**STAFF RECOMMENDATION**  
*Approval, with Conditions*

**CASE FILE NO.:** Z0229-19-D

**PROPOSAL:** Design review of alterations to an existing warehouse building and development of new three-story building on the same site. Both buildings are proposed to be used as a self-storage facility. Project will include new site access, circulation, parking, landscaping, and right-of-way improvements.

# Landscape Plan

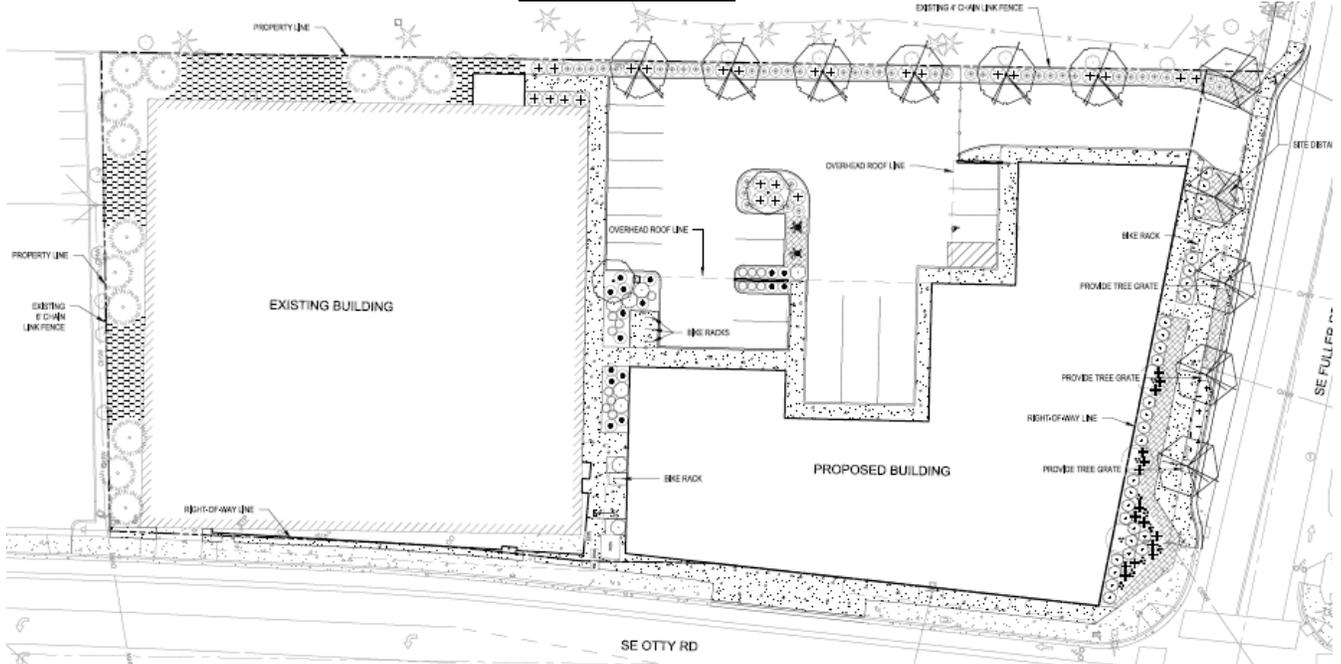
**Finding:** The proposed development is within the Clackamas Regional Center Area, which requires street trees along all streets. The site is designed with appropriate street trees along the Fuller Road frontage. Currently submitted drawings do not indicate the provision of street trees along the Otty Road frontage. **With the conditions of approval in Section 2, the above findings and the applicant's submitted drawings, the proposed development meets the standards. As conditioned, these standards are met.**

- D. Prior to issuance of building permit, the applicant shall submit a revised site/landscape drawing demonstrating the provision of street trees along Otty Road, in compliance with the standards of ZDO 1007.06(B).
